**FINDINGS OF FACT (Proposed)
FLORENCE PLANNING COMMISSION
Exhibit “A”**

Applications: PC 22 05 DR 04 & SR 22 11 SIR 06

Proposal: A consolidated application for a Design Review and Phase 1 Site Investigation Report for development of a hotel and associated improvements on an approximate 3.12-acre site.

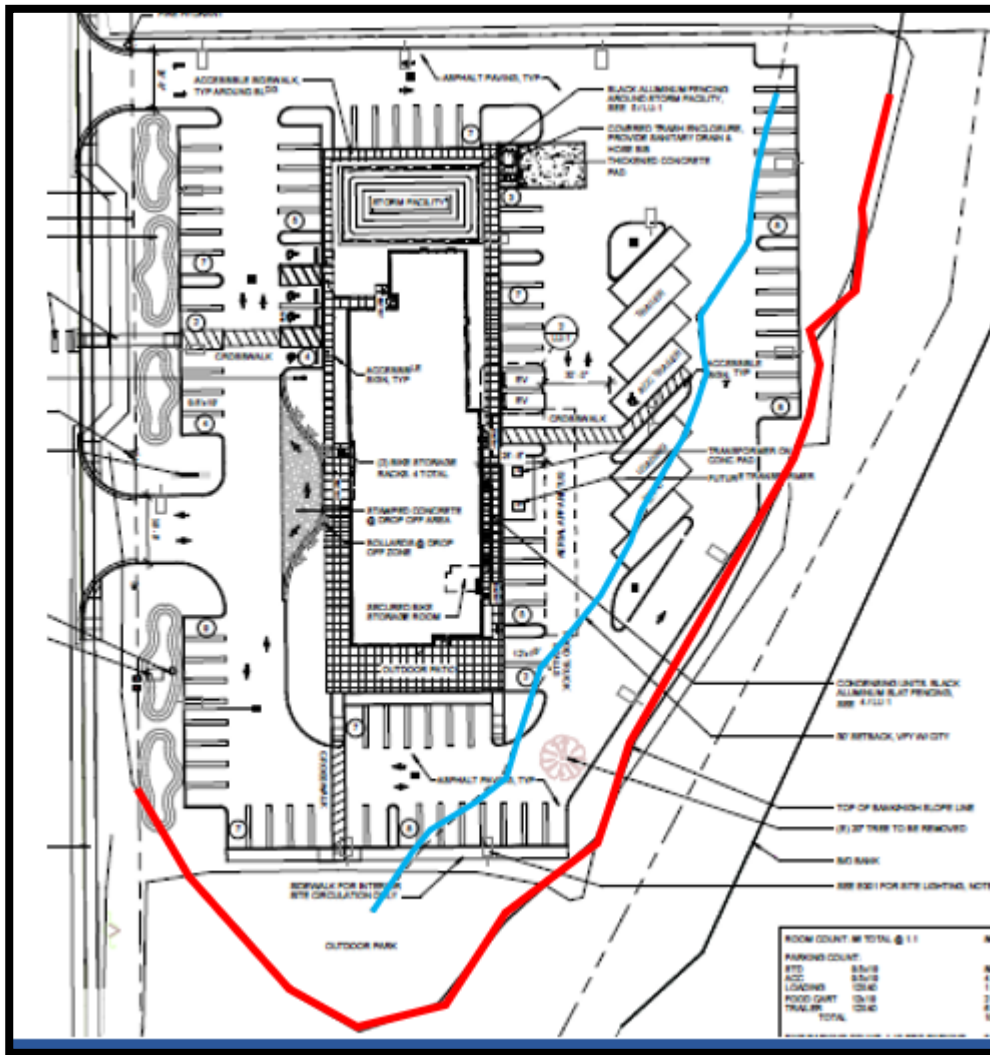
The lower elevations of the property fall within the base flood zone, yet the proposed development area is located outside of the 100-year base flood elevation. The base flood zone is located at the 14-foot elevation and the proposed development site is located at approximately the 40-foot elevation, or approximately 40 feet above the 100-year base flood elevation. The image below, taken from the current FEMA Flood Insurance Rate Map (FIRM) (effective June 5, 2020), indicates that all areas demarcated in blue lie within Zone AE meaning the Floodway. Additionally, the Base Flood Elevation (also referred to as ‘Water Surface Elevation,’) is shown to be 14-feet within this image:

Figure 10-35(4): Vision Clearance Areas
(solid lines indicate curbs or edge of pavement)

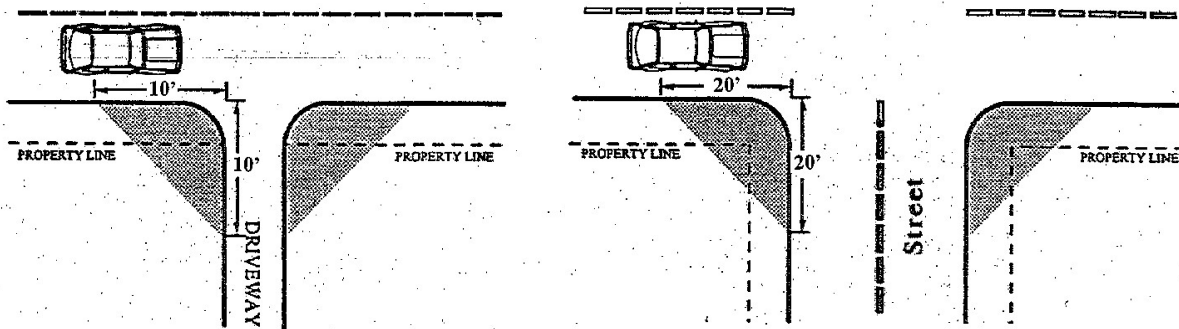
The subject property does not interact with an intersection of two streets. Vision clearance areas are shown on Sheet L1.0 of Exhibit D. No visual obstructions are proposed in the clear vision areas.

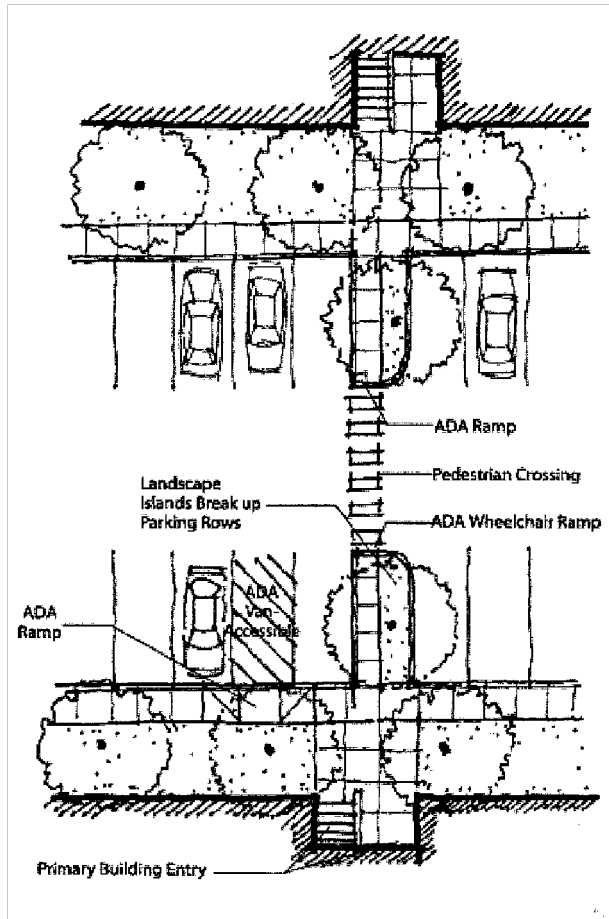
As seen on Sheet LU-1 of Exhibit D, the proposal includes three such pedestrian crossings within the parking lot. All three pedestrian crossings are greater than 24' in length. Unless the Planning Commission decides that the applicant has provided sufficient information to deviate from these standards, the crosswalks shall be clearly marked with contrasting paving materials, which may be part of a raised/hump crossing area. [Condition 10.6]

Image 1. Stop #6 on the Rhody Express near Safeway

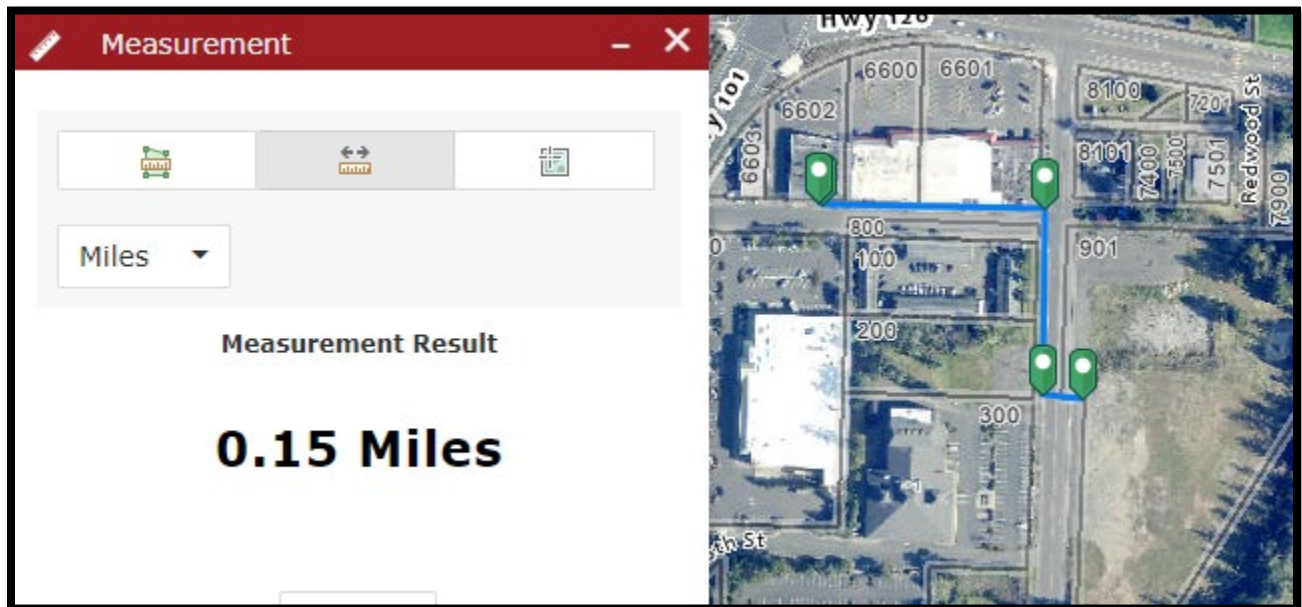
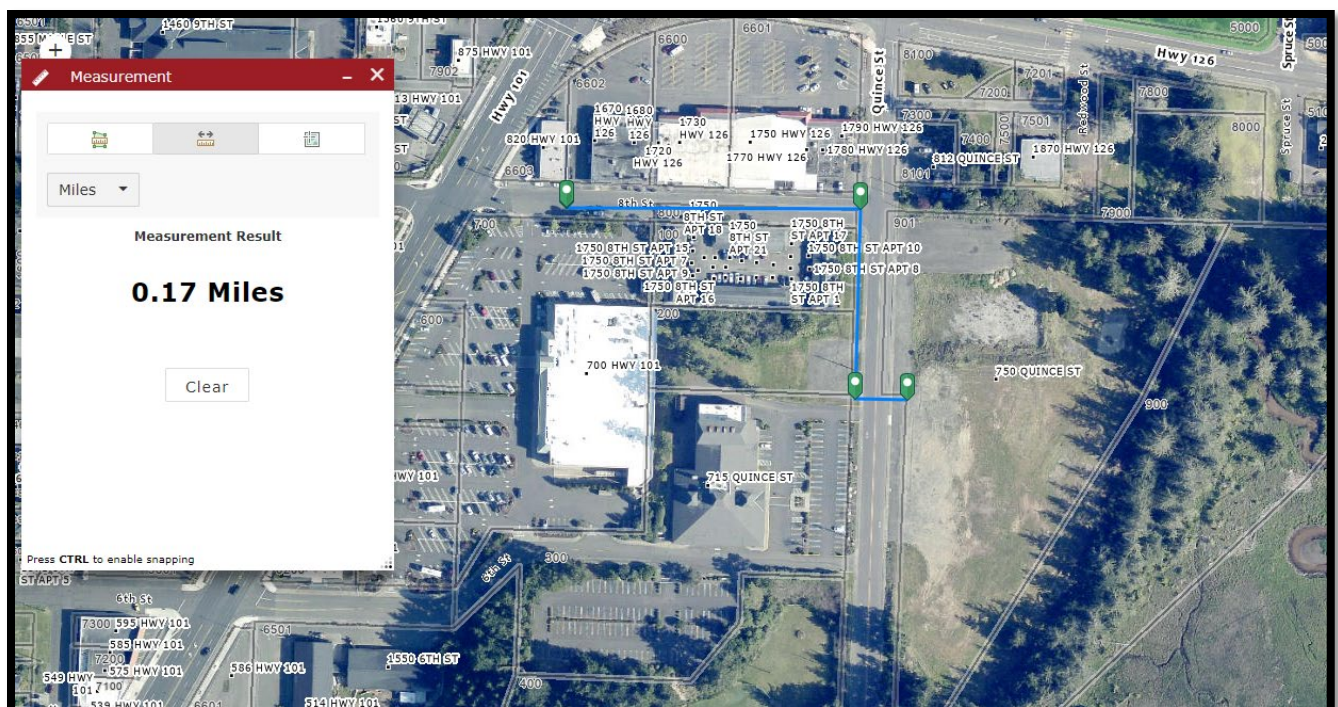
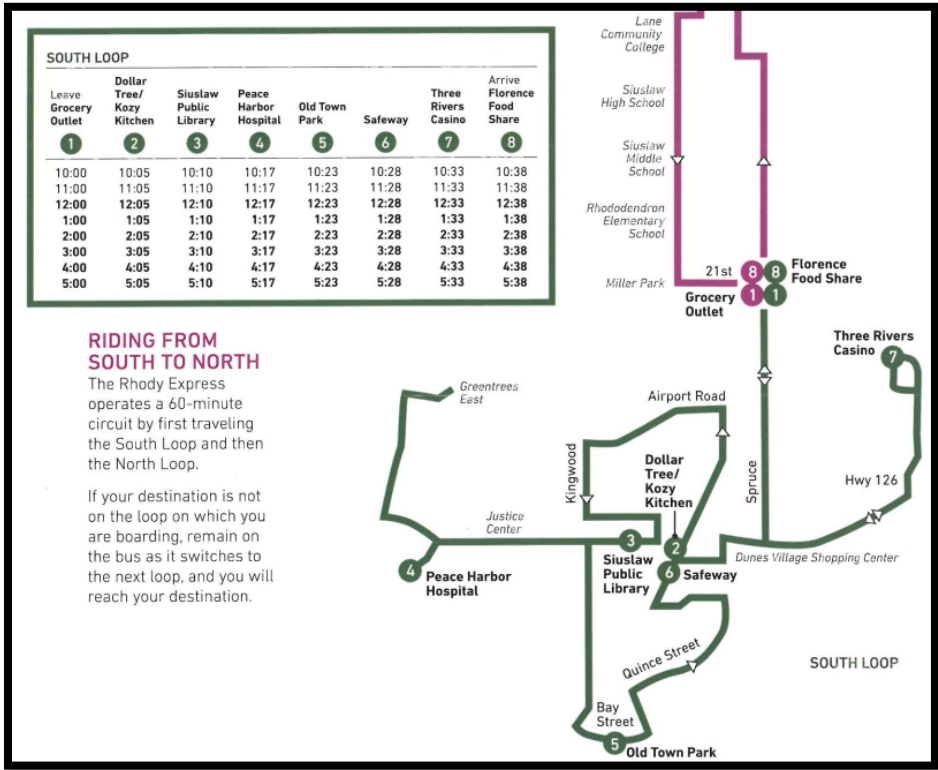
8th St, NW of Safeway (See Images 1-3, below). The approval standard is for the applicant to demonstrate a safe and direct pedestrian route from building entrances to the transit stop or to a public right-of-way that provides access to the transit stop. The applicant has provided a reasonably safe access to the Florence Events Center. From that point, pedestrians should have reasonable access at the very least to Stop #2.
